The following information is intended to address the questions from your email received July 10 and following our discussions today. This information also relates to the management of non-contact water at the site.

Responses

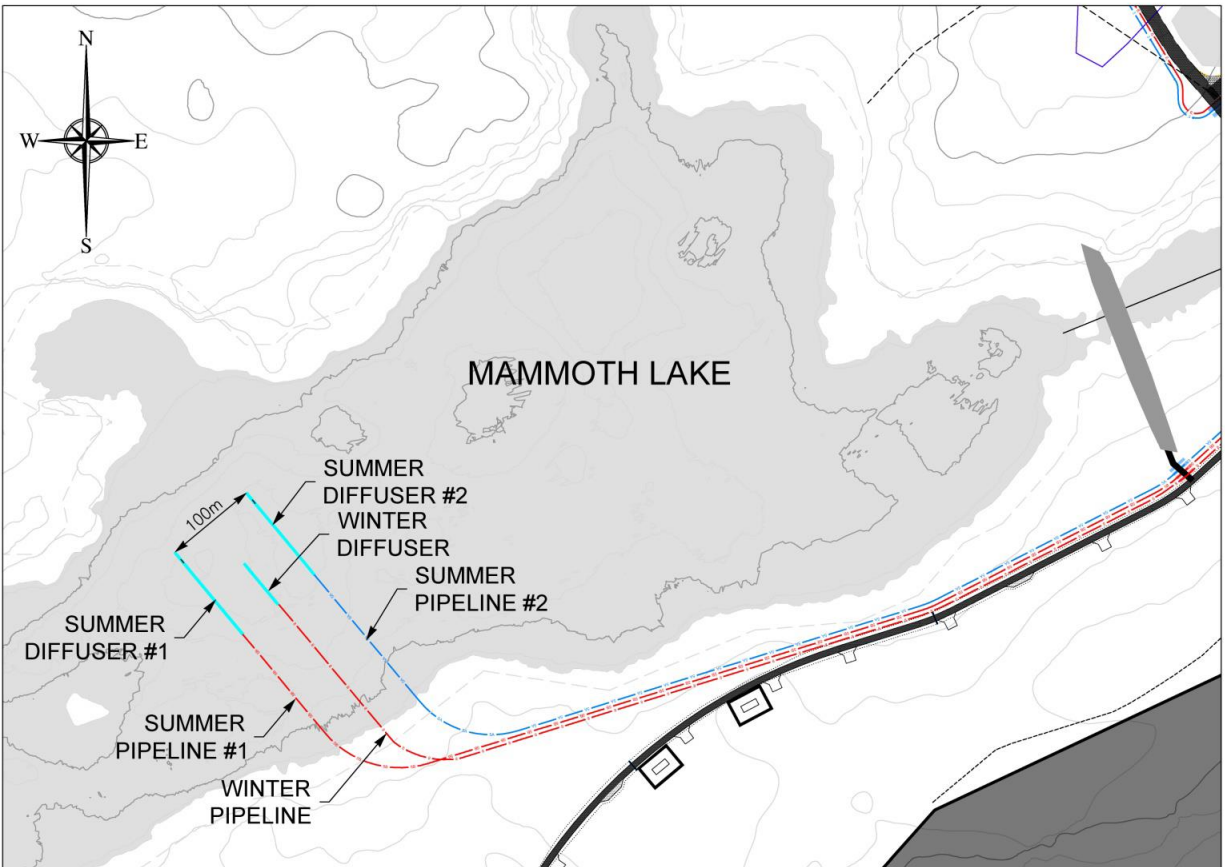
2. Can AEM justify quantitatively or semi-quantitatively (i.e., with data or via water balance calculation) why this request is necessary. What problems arose that the current set-up is insufficient? Is it just the amount of water this year or did your current set-up encounter problems.

- *The actual water volumes captured by the site, primarily spring rainfall, are higher than predicted volumes. In addition, the volume of dewatering of Whale Tail North via the Water Treatment Plant has not attained its planned capacity as there are restrictions in the piping and pumping system that remain under investigation. As such, the actual volume of water pumped is lower than predicted design criteria.*

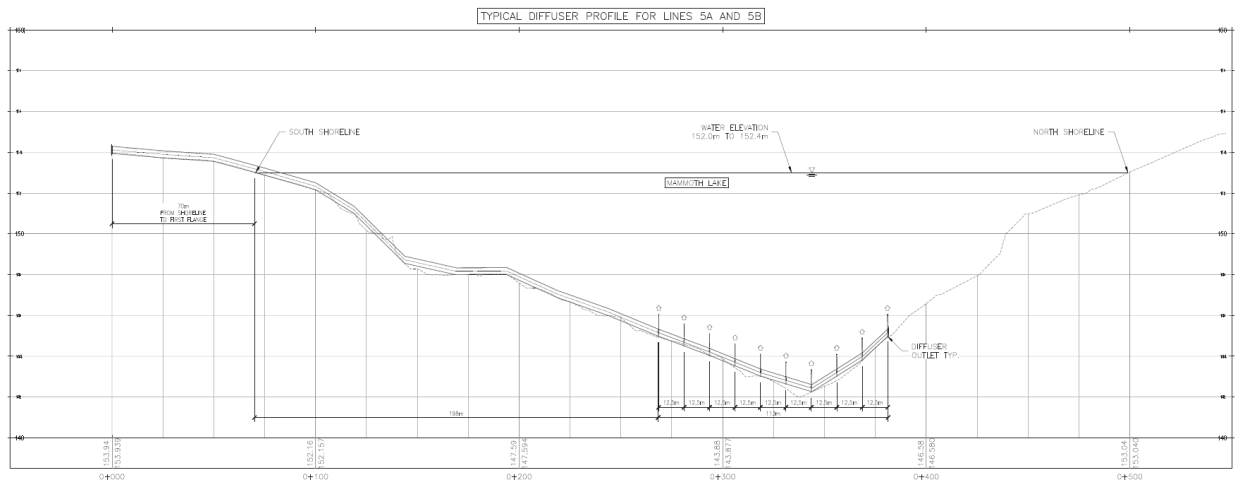
where will the new diffuser be located,

what is the water depth of the new location?

- *The locations of the diffusers were presented in the 60 days notice that was sent on February 11th 2019. Please see attached map for reference.*

- The average water depth is approximately 7 metres as per the February 11th 60 day notice.
